United Nations ST/SG/AC.10/C.3/2014/11

Manual of Tests and Criteria

Review of Test Series 8

Transmitted by the Australian Explosives Industry and Safety Group Inc. (AEISG)[1]

~~Figure 18.4.1.1: DEWAR VESSEL WITH CLOSURE~~

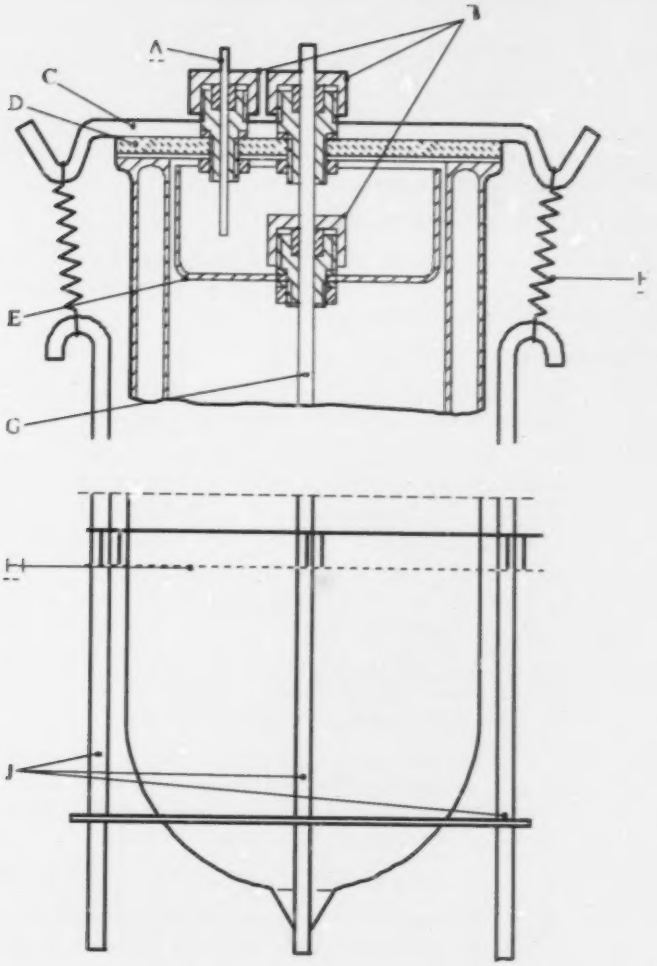
(ii) The term "Dewar vessel" has been removed throughout, replaced by "insulated test vessel" and the Figure 18.4.1.1, and any reference to it, has been removed. It is considered by various testing agencies that any insulated test vessel with the appropriate heat loss characteristics specified would be satisfactory.

18.4.1.2.4 ~~Dewar~~Insulated test vessels with a volume of approximately 500 m~~500 ml~~ with a closure system are used. The closure of the ~~Dewar~~test vessel should be inert. ~~A closure system is illustrated in Figure 18.4.1.1.~~

Figure 18.5.1.1: ANE GAP TEST

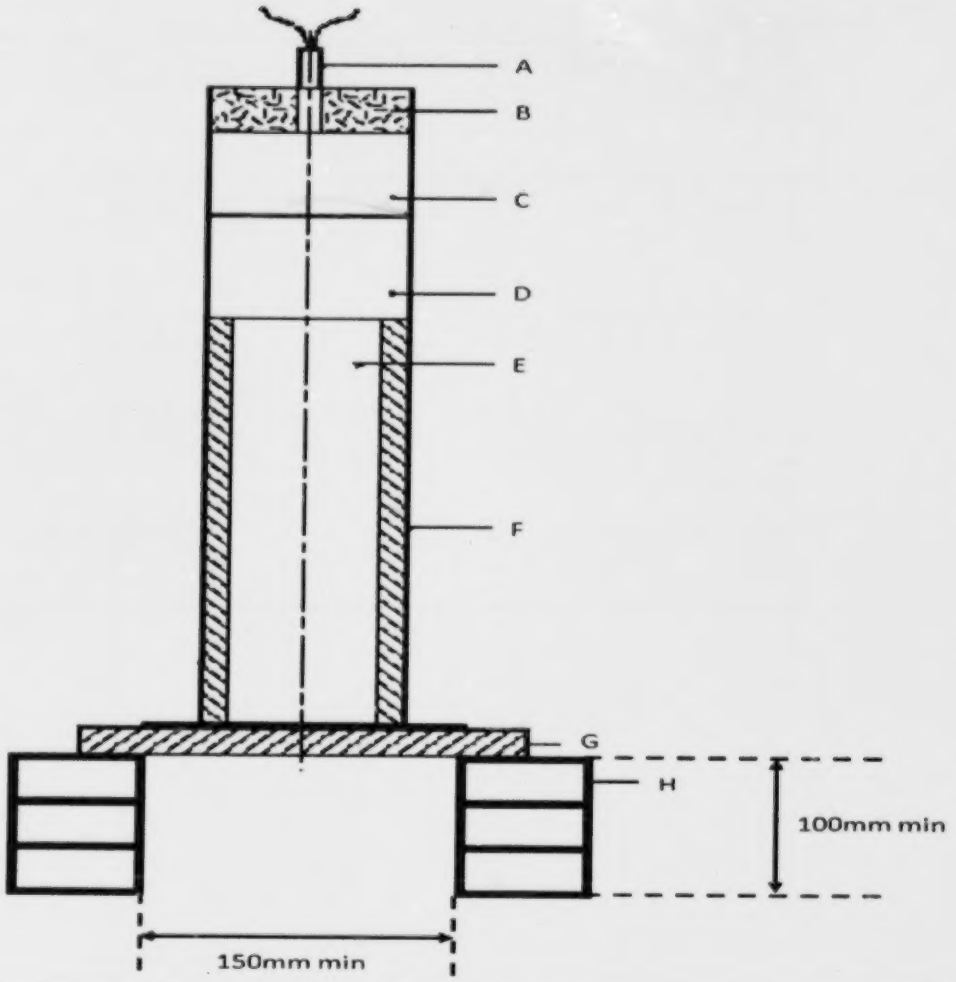
(xii) Figure 18.5.1.1 has been updated to reflect the test set up.

18.5.1.3.1 As shown in Figure 18.5.1.1, the detonator, ~~donor~~booster charge, PMMA gap and acceptor charge are coaxially aligned above the centre of the witness plate. The bottom end of the tube is sealed with a single layer of cloth adhesive tape, or equivalent, to contain the sample substance which is carefully loaded so as to avoid the formation of voids within the sample or between the sample and the tube walls. The surface of the sample should be level with the rim of the tube. Care should be taken to ensure good contact between the detonator, the booster charge, ~~and donor, donor and gap and~~the PMMA cylinder ~~gap~~ and the acceptor charge. ~~The test sample and booster should be at ambient temperature for the test.~~ The sample substance should be at ambient

Figure 18.5.1.2: ANE Gap Test Calibration Data

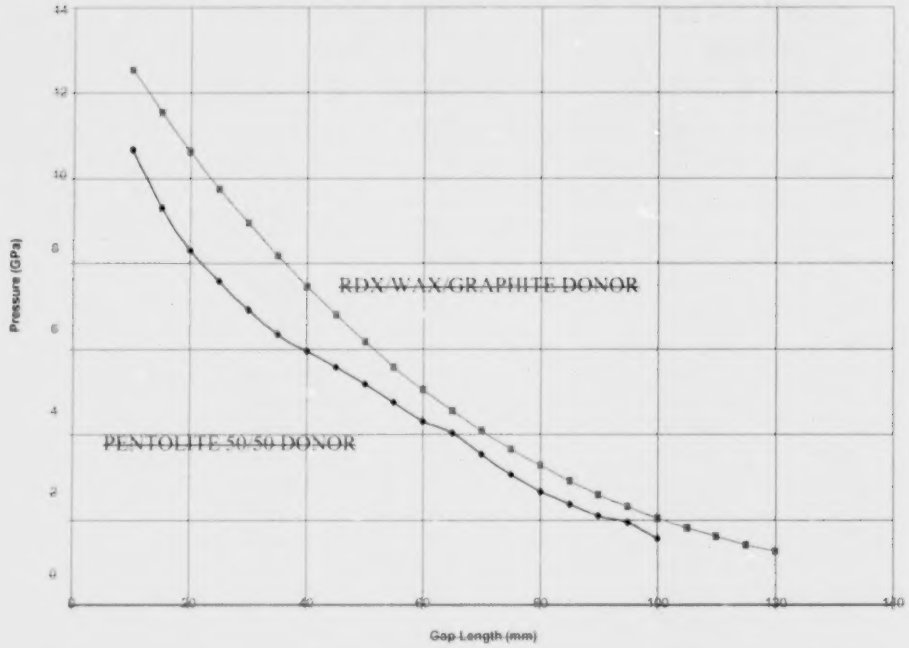
(vi) In 18.5.1.2.1(e) references to the shock pressures, Table 18.5.1.1 and Figure 18.5.1.2 are removed as irrelevant here. The particular Table and Figure referenced are also removed as irrelevant here (these may be considered as useful information for the Appendices).

(e) Polymethyl methacrylate (PMMA) rod, of 95 mm diameter by 70 mm long; ~~A gap length of 70 mm results in an incident shock pressure at the ANE interface somewhere between 3.5 and 4 GPa, depending on the type of donor used (see Table 18.5.1.1 and Figure 18.5.1.2);~~

Figure 18.6.1.1: Test Tube Assembly

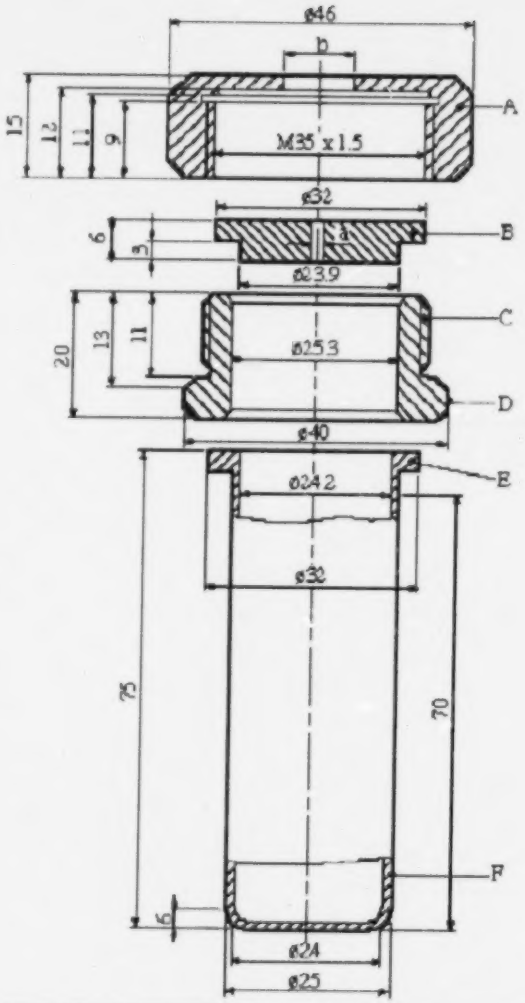
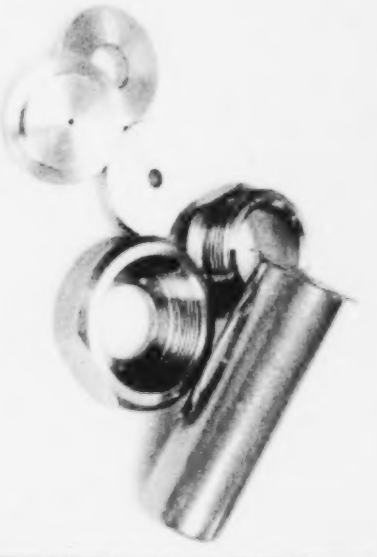
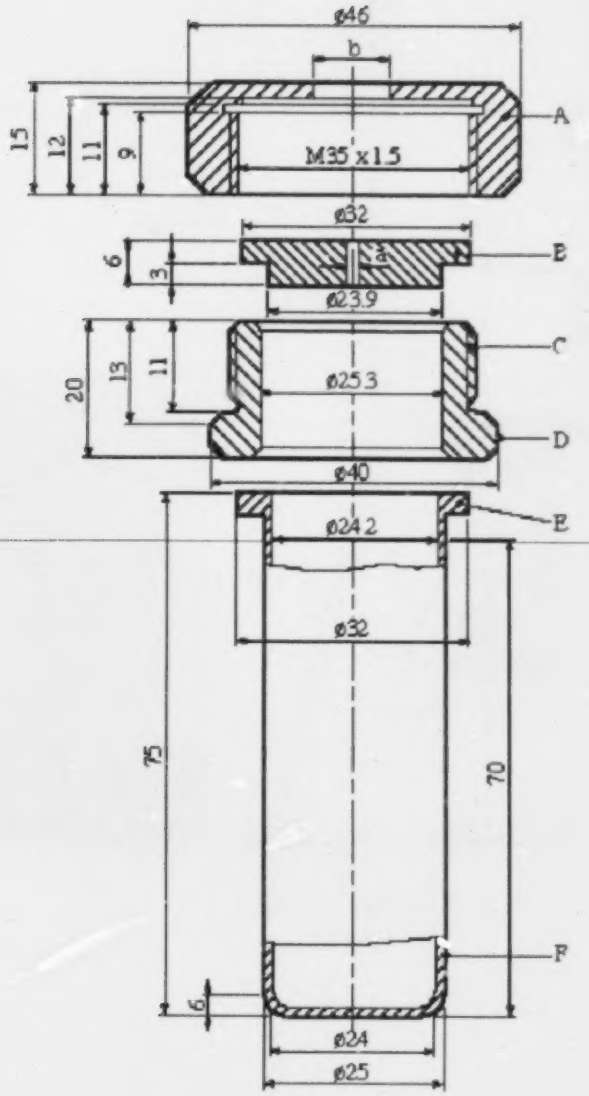
(i) In 18.6.1.2.1 reference to various diameter orifice plates is removed with only those relevant to this test retained i.e. 1.5 mm for the calibration and 2 mm for the test.

(ix) Figures have been updated to provide more guidance, clarity.

~~18.6.1.2.1 1.0 1.5 2.0 2.5 3.1 5.0 8.0 12.0 20.0 mm.~~ The dimensions of the threaded collar and the nut (closing device) are given in Figure 18.6.1.1.

Figure 18.7.1.1: VENTED PIPE TEST

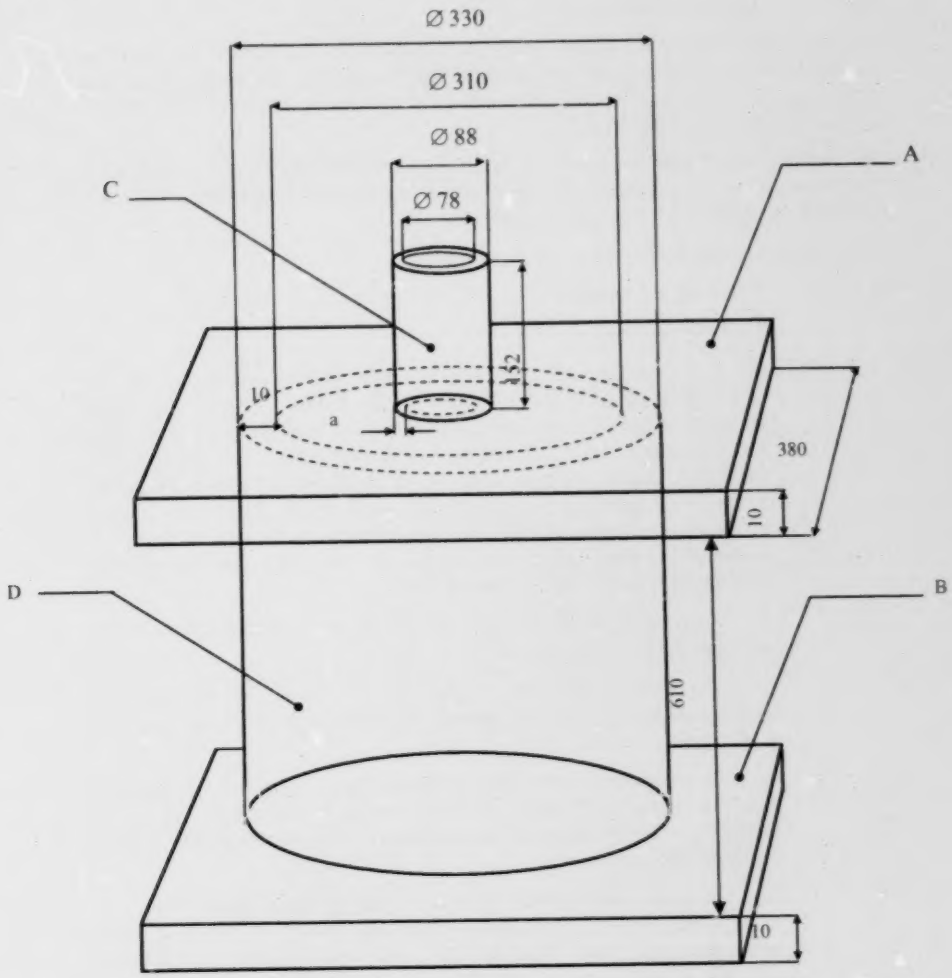
(ii) In 18.7.1.2(a) a quality standard has been added for the welding of the test assembly. The specification for the steel has been included here – taken directly from the Figure 18.7.1.1.

(a) A steel pipe 310 ± 10 mm diameter and 610 ± 10 mm long, welded close at the bottom with a 380 mm square, 10 ± 0.5 mm thick mild steel plate. The top of the pipe is welded to a 380 mm square, 10 ± 0.5 mm thick mild steel plate that contains a 78 mm diameter vent hole centrally located in the plate to which a 152 mm long steel pipe nipple of 78 mm internal diameter is welded (see Figure 18.7.1.1). All welding should be to a relevant ISO standard or equivalent. All steel components are to be Schedule 40 carbon steel (A53 Grade B) or equivalent;
